SERVICE BULLETIN

No: SB192-19

Elite 6 ETS Rear and Mid Steer Axle Bracket Bolt Torque

Fig 1

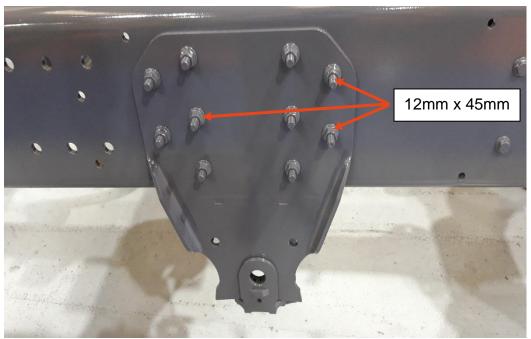
Dennis Eagle recommend on your vehicle's next six weekly safety inspection that bolts on the ETS mid or rear steer spring hangers are physically torqued to 120Nm.

All bolts are part number DEP104208 apart from the three bolts clearly marked in Fig. 1, these are DEP104207, all nuts are DEP104234.
